AMENDED BY STAFF 6-29-88  
**CITY PLANNING COMMISSION**

- APPLICATION:
- A. Negative Declaration
  - B. Amend City Agreement 82055 (Gateway Centre Development Agreement) to compute exactions on an acreage basis for the commercial acreage in the Gateway Centre PUD

PROPOSAL: The applicant is requesting the necessary entitlements to construct a 150 room Marriott Courtyard (hotel/motel/motor lodge) on a 3.8+ acre site located in the Gateway Centre Planned Unit Development.

APPLC. NO. P88-218 MEETING DATE 18 June 23, 1988 ITEM NO. 20

# EXHIBIT C

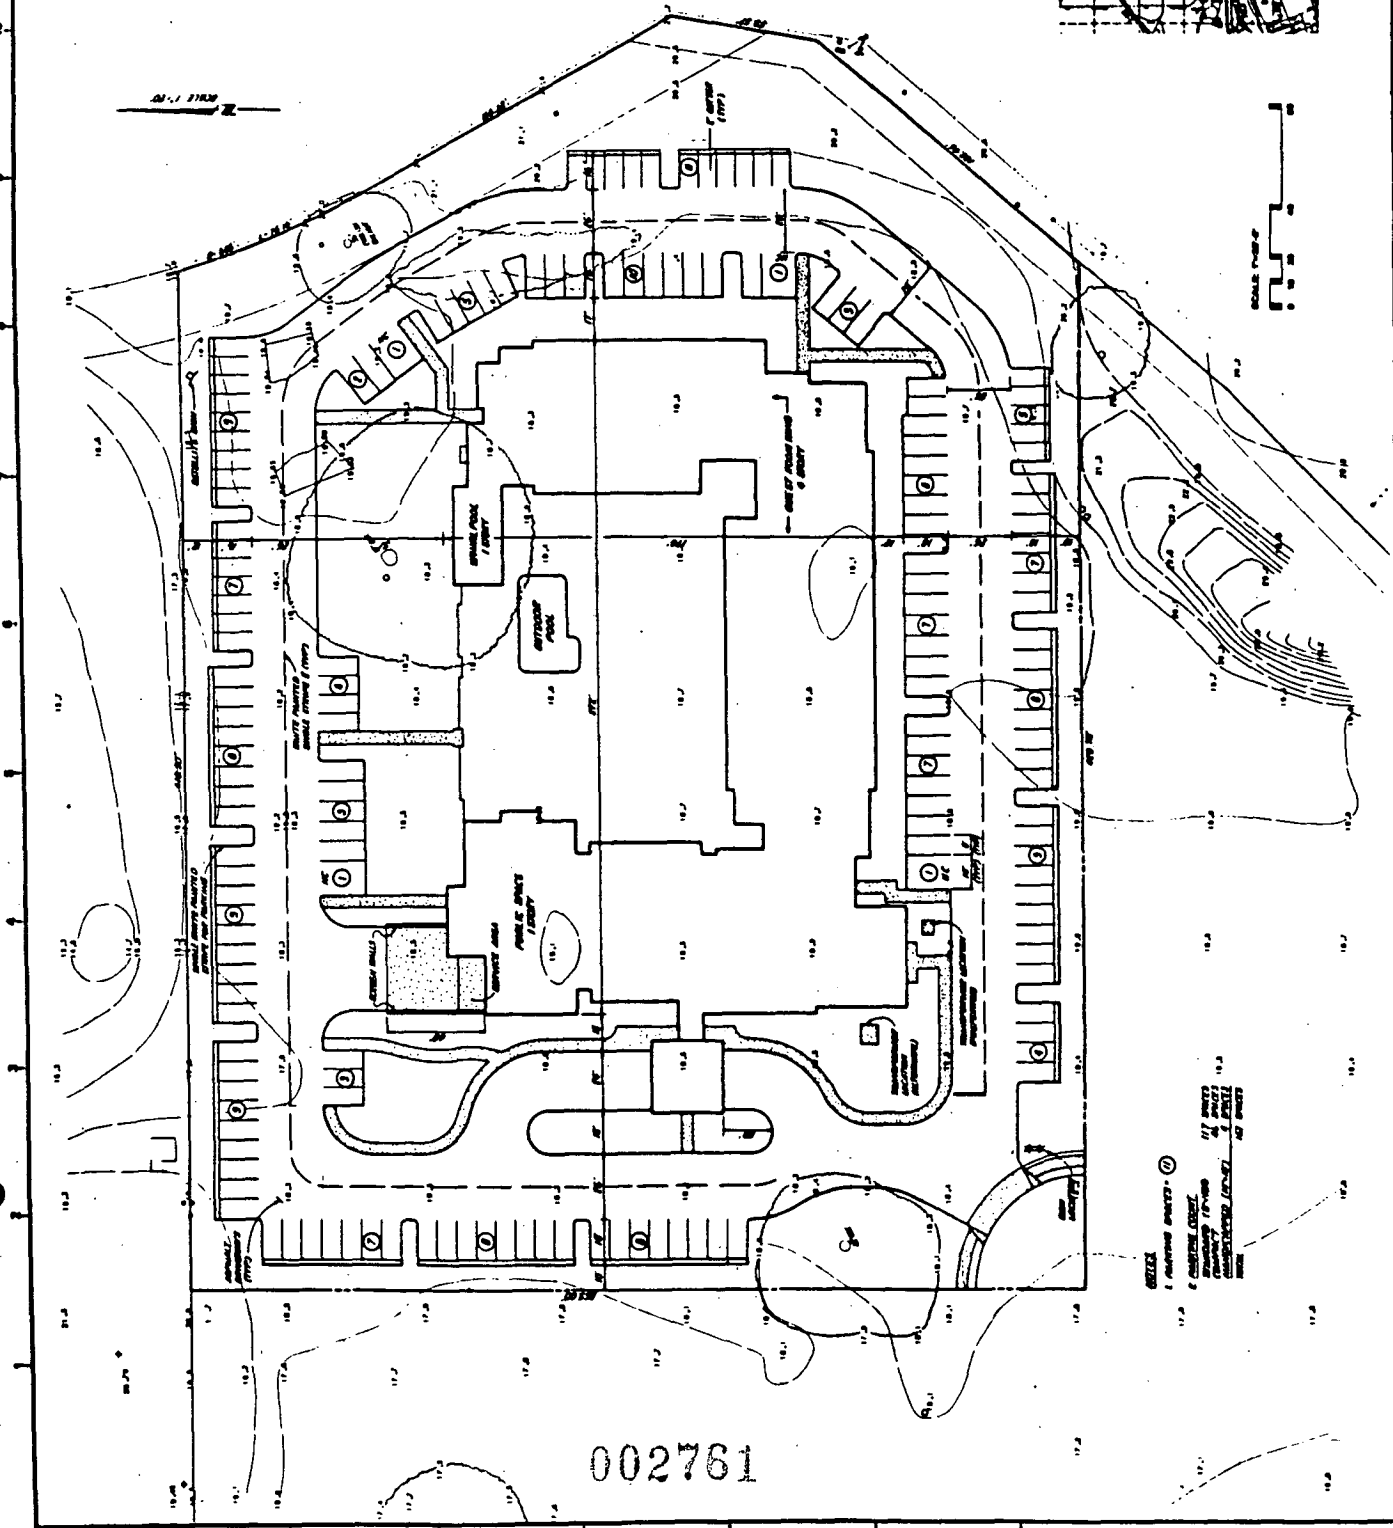
The submitted site plan indicates the required 25-foot landscape setback adjacent to the public street (cul-de-sac entrance) and the 25-feet of landscaping adjacent to the east property line as required for the I-5 scenic corridor (Exhibit C). The submitted landscape plan does not detail landscaping in the required 25-foot front setback (Exhibit D). Due to the limited street frontage on the cul-de-sac it may be difficult to provide the standard three to four foot high undulating berms. Planning staff recommends that the landscaping for this area be detailed on revised landscape plans and that the plans attempt to provide for continuity with the future 25-foot landscaped setbacks on the adjacent parcels.

Two large oak trees which have been determined to be significant by the City Arborist are also located on the subject site. The applicant has positioned the Courtyard building and the driveways and parking areas so that these two trees can remain on the site. As a result, a small portion of the subject building is 80 feet from the I-5 on/off ramp (Exhibit E). The PUD Development Guidelines indicate that the building setback from the exterior right-of-way line is to be 100 feet. The proposed building, however, could not be relocated further west on the site unless the one oak tree was removed or the number of parking spaces were reduced. The applicant, therefore is requesting a variance from the development guidelines to reduce the required 100 foot setback for a portion of the building. Due to the physical constraints of the subject site and that the building is within 100 feet of the freeway on/off ramp rather than the main roadway, Planning staff has no objections to the variance request.

A satellite dish is indicated on the site plan adjacent to the north property line. Planning staff recommends that the dish be screened from the I-5 freeway and the adjacent property to the north by shrubs and a solid material compatible with the main building (stucco material).

A trash dumpster is not indicated on the site plan. Staff noted, however, on a visit to the existing Marriott Courtyard in Rancho Cordova that an outside dumpster was located in the service area. A trash enclosure which meets Zoning Ordinance requirements will be required for any outside dumpster.

The applicant's original site plan indicated 156 parking spaces. At staff's request the applicant revised the site plan and was able to provide 167 parking spaces on the subject site. The applicant has indicated that the restaurant and lounge would not be advertised to the general public and that the meeting rooms are for guests only.

1. A revised landscape plan shall be submitted for Planning Director review and approval prior to issuance of building permits. The plan shall detail proposed landscaping for the required 25-foot front landscape setback which will be compatible with the landscape setback of adjacent properties. The landscape plan shall adhere to the landscape requirements of the development guidelines and the approved PUD plant list.
2. Plans for the proposed satellite dish including a solid screening structure (stucco material) and landscaping adjacent to the satellite dish shall be submitted for the review and approval of the Planning Director prior to installation of the satellite dish on the subject site.

3. One-hundred sixty-seven (167) parking spaces shall be provided on the subject site. Bicycle parking per Zoning Ordinance requirements shall also be provided.

EXHIBIT H  
Elevations

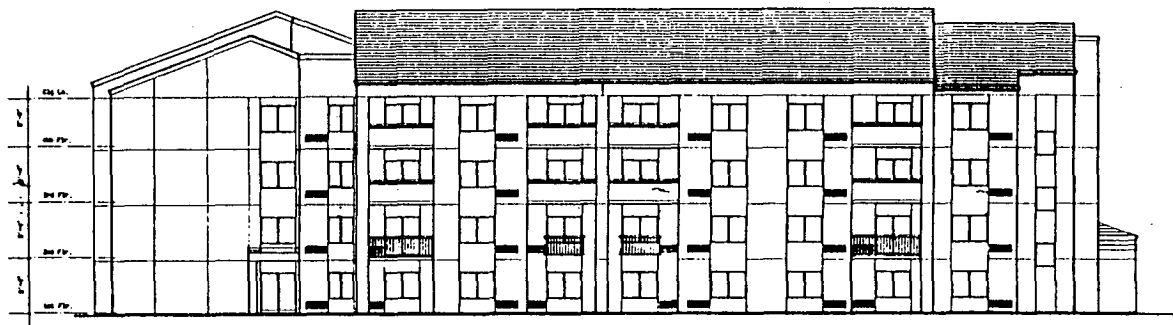
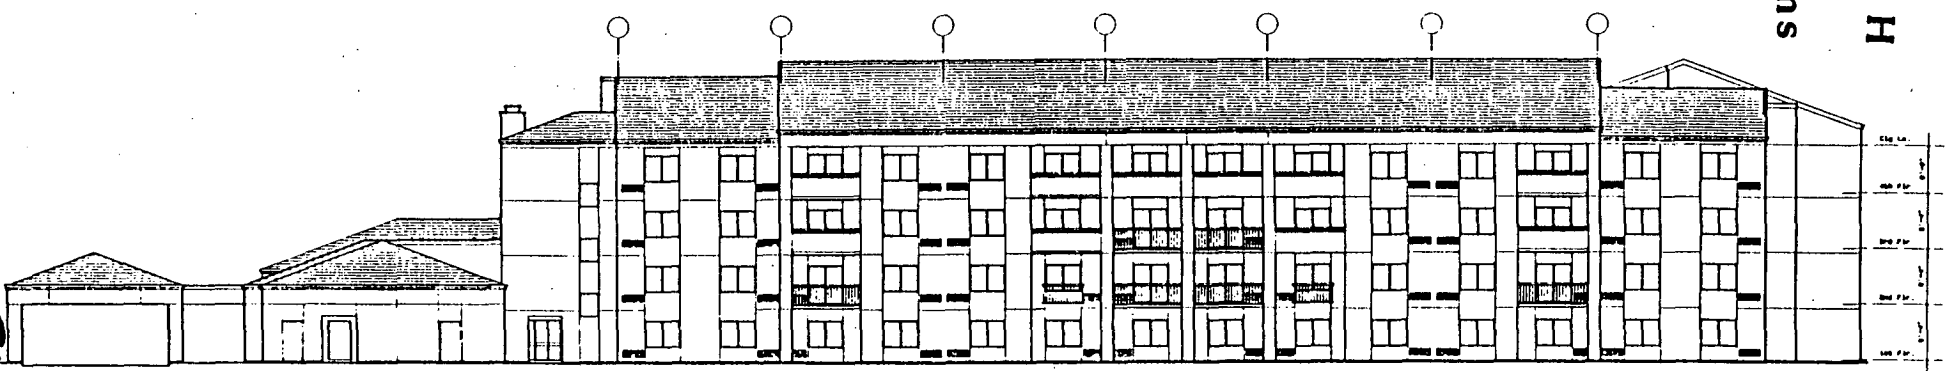
The original elevations submitted to planning staff indicated a flat roof on the building except at the porte cochere which had a pitched roof. Staff felt that a pitched roof design for the entire building would be more complimentary to the structure and compatible with the surrounding office park and multiple family residential to the west. Staff also felt that the exterior elevations presented a box-like structure that was too massive for the area and lacked articulation. In order to resolve these design concerns, Planning staff met with the architect for the Marriott Corporation to discuss the project. As a result of this meeting revised plans which indicate a pitched roof on the structure have been submitted (Exhibit F, G and H) and the Marriott Corporation has indicated that they will make the following revisions to the building elevations:

1. Facade shall be modified to indicate pulled back panels between the flush facade windows and change of color in these areas.
2. Horizontal accent panels shall be placed on other portions of the facade, porte cochere and entrance to building.
3. Color accent band shall be placed at top of building below roof.
4. Wider control joints shall be added at all horizontal locations.
5. All rails, windows and doors shall be color coordinated.

5. The proposed building shall indicate a pitched roof design as indicated by Exhibits F, G and H. The applicant shall make the following revisions to the building elevations subject to Planning Director review and approval prior to issuance of building permits:

- a. The facade shall be modified to indicate pulled back panels between the flush facade windows and a change of color in these areas.
  - b. Horizontal accent panels shall be placed on other portions of the facade, porte cochere and entrance to the building.

- c. Color accent band shall be placed at top of building below roof.
  - d. Wider control joints shall be added at all horizontal locations.
  - e. All rails, windows and doors shall be color-coordinated.
